**ADDENDUM NUMBER: TWO**

**ISSUED BY: SEPW Architecture Inc.**  
109 – 3725 Pasqua St., Regina, SK. S4S 6W8  
PH. (306) 569-2255

**PROJECT: INTERIOR RENOVATION  
PROJECT #42/17  
REGINA, SASKATCHEWAN**

**AR1**

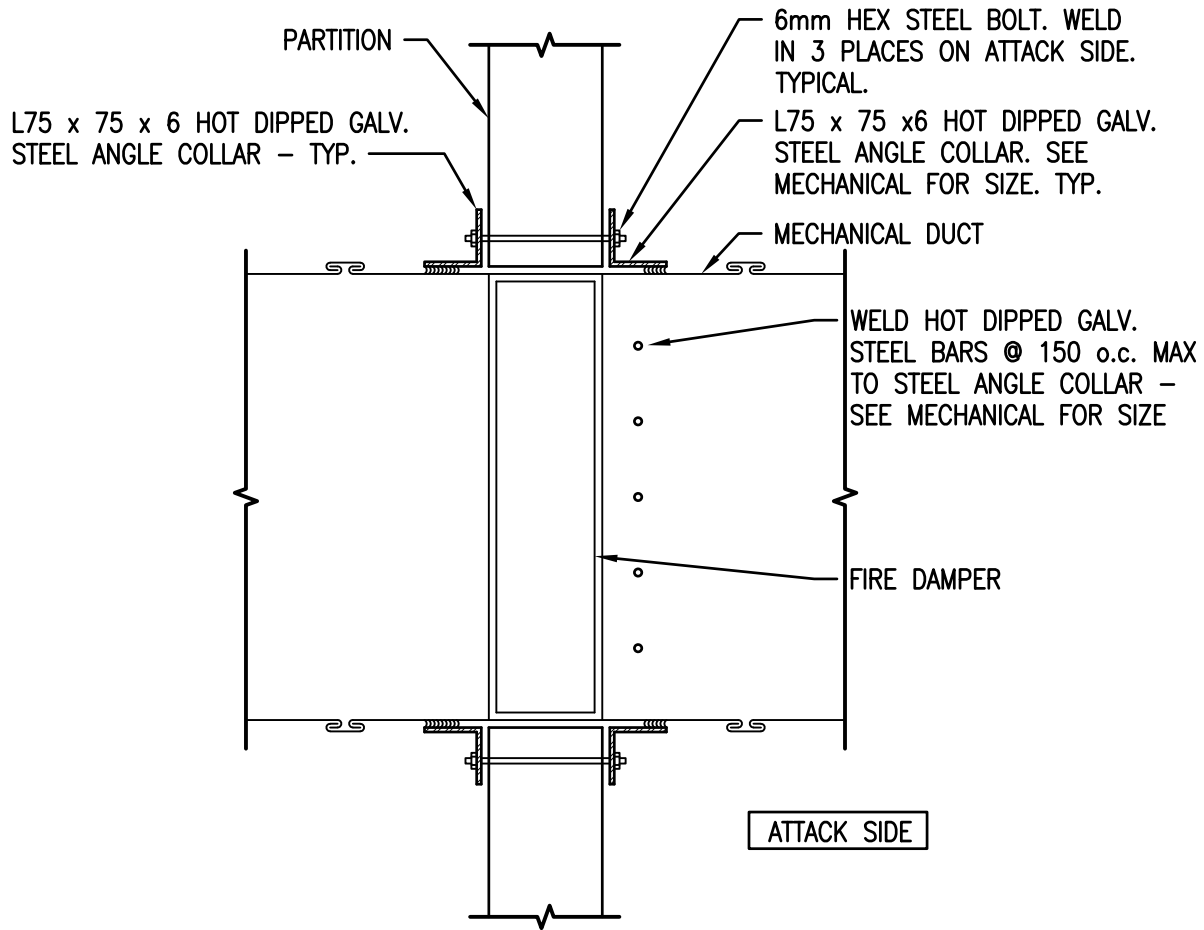
CLARIFICATION: provide security bars as detailed in drawings AR1, AR2 and AR3 in locations as noted in drawings. Adjust dimensions to suit duct size.

**AR3**

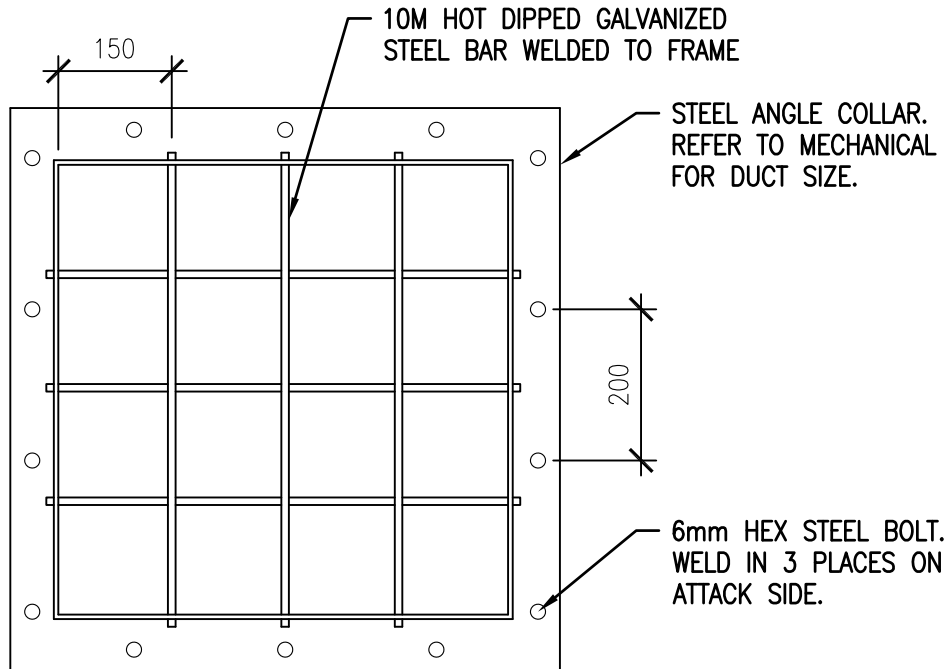
REFER TO MECHANICAL FOR DUCT LOCATIONS. PROVIDE AT ALL SECURE WALL LOCATIONS, REFER TO PARTITION SCHEDULE.
